# Rezoning Transportation Analysis

Petition Number: 2019-128

## Revision Log:

Date	Description
10-21-2019	First Review
06-26-2020	Second Review

## TYPICAL SECTION

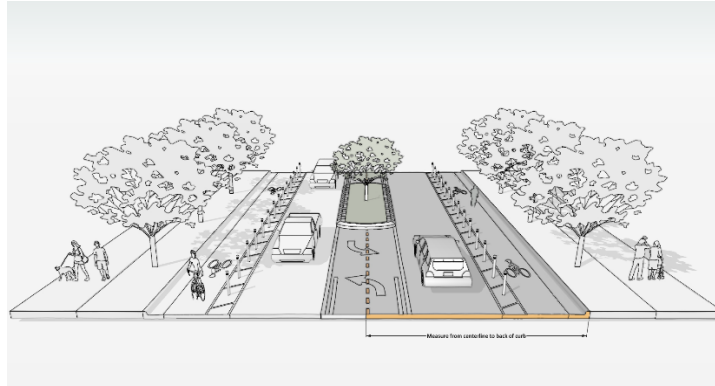
1. **Curbline** The proposed zoning district has a setback measured from back of the existing or proposed future curbline.
  - a. **Steele Creek Road:** The future location of curb and gutter will be constructed within the Steele Creek Road (NC 160) U-5766 project. The public meeting map and proposed cross section are provided below for reference.

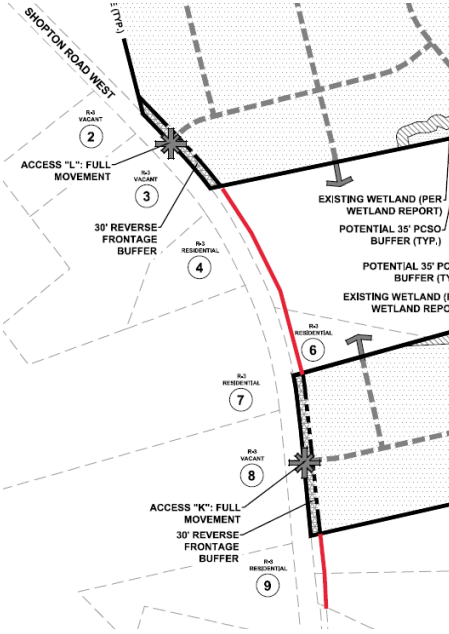
3. The petitioner should revise the site plan and conditional note(s) to commit to dedicate 43 feet of right-of-way from the existing Sledge Road centerline. The site plan should label and dimension the right-of-way from the road centerline.
4. The petitioner should revise the site plan and conditional note(s) to commit to construct an 8-foot planting strip and 6-foot sidewalk along the frontage of Sledge Road. The site plan should label and dimension both items from the back of curb and gutter and road centerline.

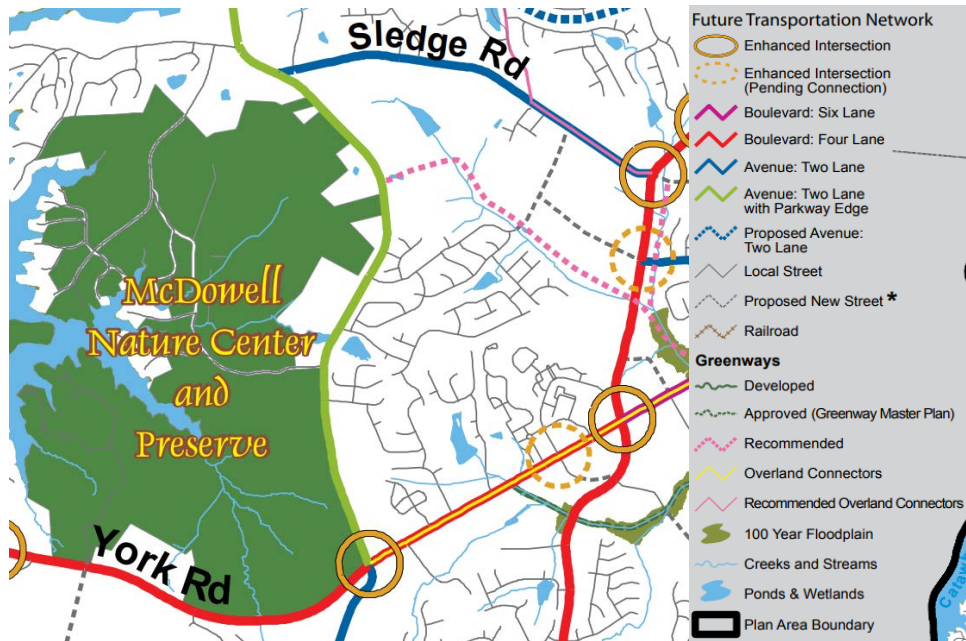
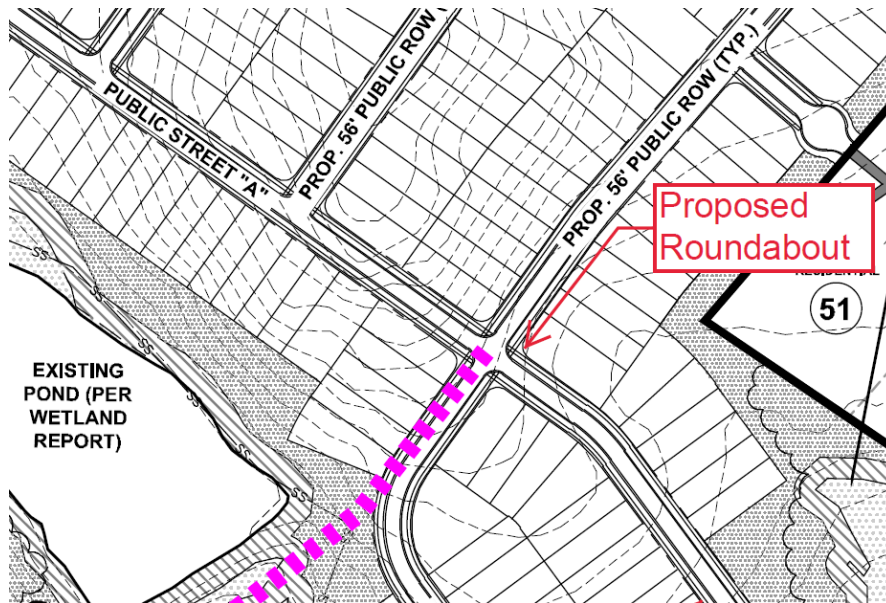
- The petitioner should revise the site plan and conditional note(s) to incorporate a proposed mini-roundabout on proposed Public Street "A."

- The petitioner should revise the site plan and conditional note(s) to revise Public Street "A" to a Local Collector Street Section, per CLDSM U-07, as required by Sec. 20-23(k) of the Subdivision Ordinance and the City-council adopted Collector Street Map. In-lieu of the proposed 10-foot multi-use path, a 12-foot multi-use path should be provided along the western streetscape to provide an overland connector to the recommended greenway alignment to the McDowell Nature Center and Preserve.

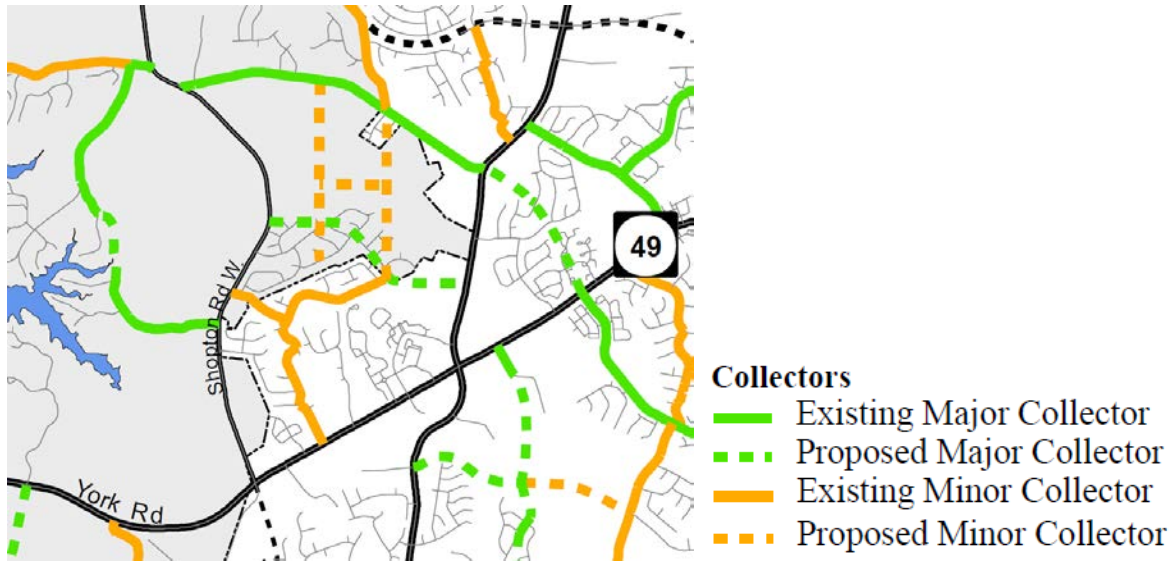
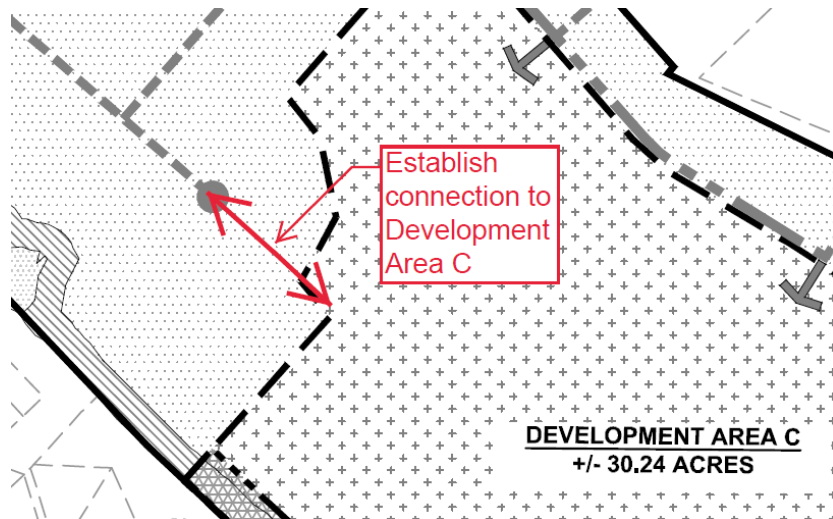
14. The petitioner should revise the site plan and conditional note(s) to establish a street connection to "Development Area C."
